Clonberne Wind Farm

Stage 1 Road Safety Audit

JOB NUMBER: 240018			DOCUMENT REF: 240018RPT001_RSA1_Rev_1			
1	Final Issue	MD	MD	JW	MD	8 June 2024
0	Draft Issue	MD	MD	JW	MD	14 Feb. 2024
Revision	Purpose Description	Originated	Checked	Reviewed	Authorised	Date

Figure 2.2 – Road Crossings - Access Junction B (Left) & Access Junction C (Right)

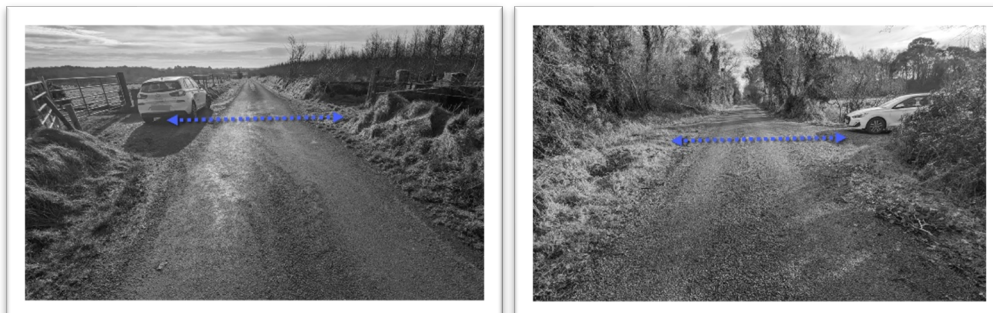
2.2 Problem: Failing to Stop Type Collisions

Location: Access Junctions B & C | Road Crossings

A number of the site access road approaches are long and straight. This could lead to higher approach speeds and 'failing to stop' type conflicts on the Local Roads.

Appropriate (self-regulating) temporary traffic management measures should be set in place to throttle construction traffic speed and to reduce the risk of collisions on the Local Road crossings.

Design Team Note 2 – It is proposed that signs will be put in place on the access road approaches to the local roads at Junctions B and C and that appropriate traffic management measures, including a Flagman, will be on site at all times during the construction phase. The site accesses will be closed by means of gates during all times that the accesses are not in use during construction. During the operational stage the default will be that the accesses will be closed using gates at all times and opened only during site visits made by maintenance staff. It is noted that visibility splays appropriate for the local speeds on the local road network are available at both junctions, as shown in Figures 15-33 and 15-34 of the EIAR.

Figure 2.3 – Higher Speeds Observed on Southbound L-2232 Approach to Access Junction F

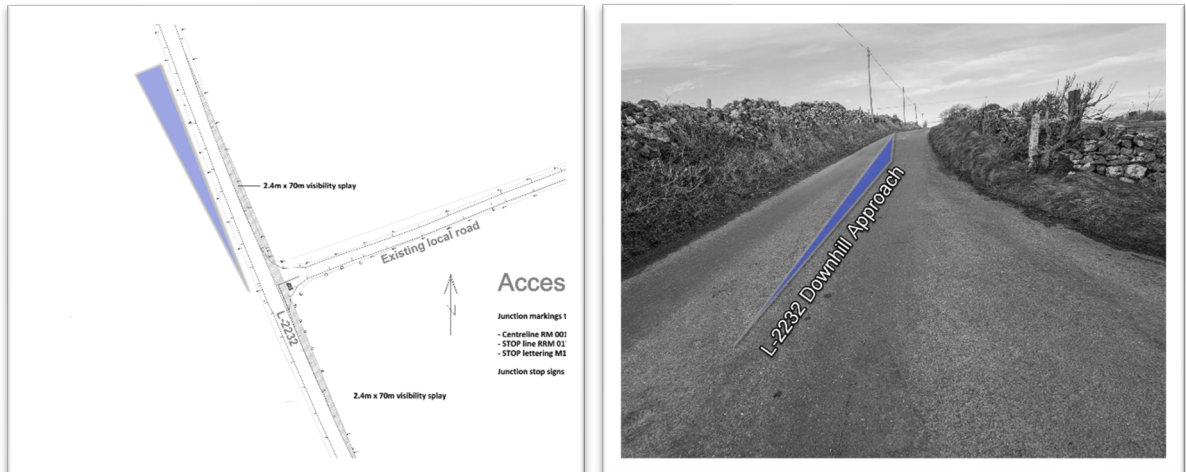
2.3 Problem: Higher Vehicle Speeds on Downhill Approach

Location: Access Junction F | Southbound Approach on Local Road L-2232

The downhill approach to Access Junction F is likely to result in higher vehicle speeds. This could increase the likelihood and the severity of a collision at the junction.

Appropriate signage and road markings should be set in place to inform drivers (including drivers of construction related traffic) of the approaching junction and warn them to throttle their approach speeds.

Design Team Note 3 – It is noted that this is an existing junction and during the days that it is used to transport materials from the borrow pit to the site the junction will be controlled by traffic management measures, including temporary signing and a Flagman, which will calm local traffic speeds. Once the construction phase is complete there will be no development generated traffic passing through this junction.
